Summary:

The purpose of the return to Five Guys #0233 Lancaster, PA is to determine current ductwork configurations and limitations in hopes of finding a way to get conditioned air onto the cookline. NTAB found that from the West end of the building to the left end of the hoods there are obstructions preventing any further routing of ductwork to the Cookline. The only way to get conditioned air from the Kitchen AC unit would be to add a no larger than 10"X14" duct (due to Truss opening limitations) connecting from the main trunkline and routing it above the doorway, have a 90 degree elbow that runs parallel to the hood. This configuration would allow for multiple connection points to new linear diffusers, Note that between the serve counter lighting and existing MUA linear diffusers there is plenty of space above ceiling. For optimal performance it is recommended that the existing supply trunk be opened up to 20X14" to allow for maximum flow to the new and existing ductwork. Existing MUA linear diffusers would have to be rotated 180 degrees to prevent spacial conflict with new conditioned air linear diffusers.

see Existing Layout:

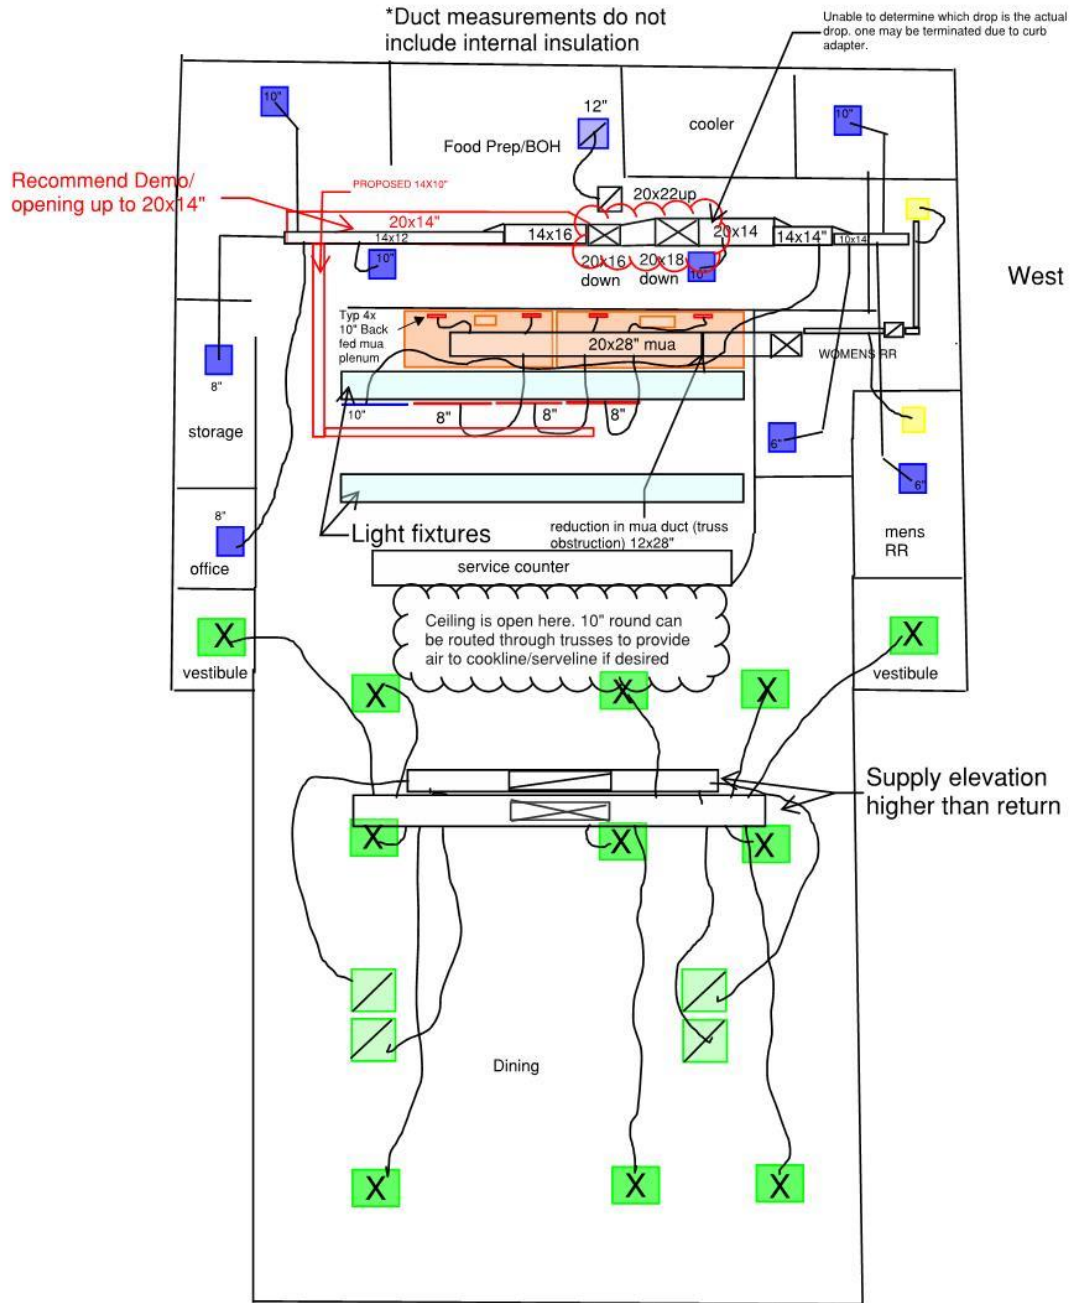
New duct connection point: Note Existing flex will obstruct and needs to be rerouted.

Room To Demo existing trunk and expand to 20X14 or greater: There is no limitation horizontally.

New L-shaped duct: Route through Truss' and elbow into open ceiling area parallel to hood/existing linear diffusers.

Run Duct Parallel to hood/existing linear diffusers: Flex in new linear diffusers next to existin MUA linear Diffusers.

Existing Linear diffusers: Stack new linears next to existing linears.

Existing Linears need to be rotated 180 Degrees: Current flex configuration would interfere with new linear diffusers.
